BEAVER VALLEY POWER STATION, UNIT NO. 1

AMENDMENT TO FACILITY OPERATING LICENSE

Amendment No. 121  
License No. DPR-66

ATTACHMENT TO LICENSE AMENDMENT NO. 121

FIGURE 5.1-1

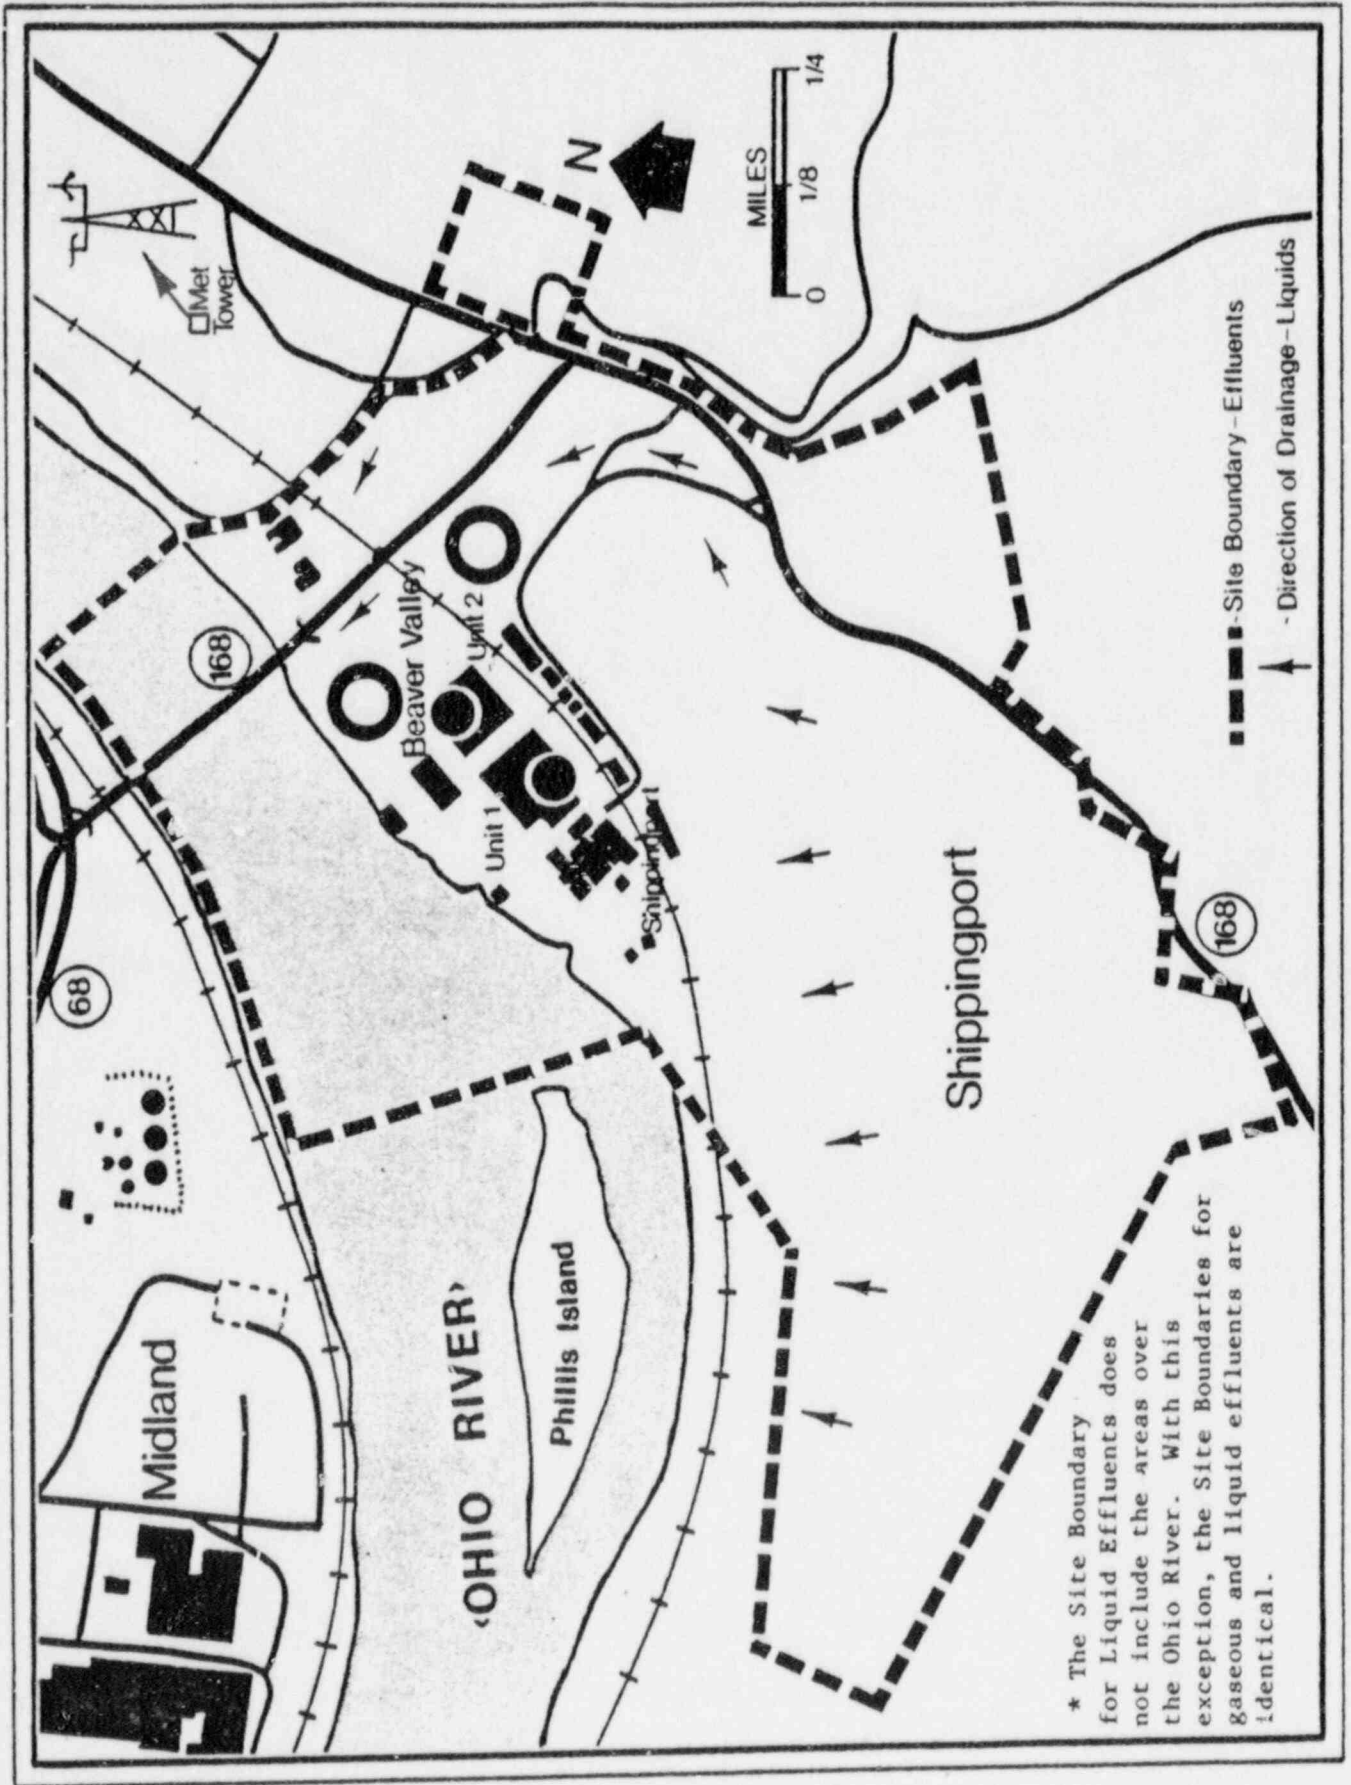
Replace the following pages of the Appendix A Technical Specifications with the enclosed pages as indicated. The revised pages are identified by amendment number and contain vertical lines indicating the areas of change.

SITE BOUNDARY FOR GASEOUS AND LIQUID\* EFFLUENTS  
FOR THE BEAVER VALLEY POWER STATION

\* The Site Boundary for Liquid Effluents does not include the areas over the Ohio River. With this exception, the Site Boundaries for gaseous and liquid effluents are identical.
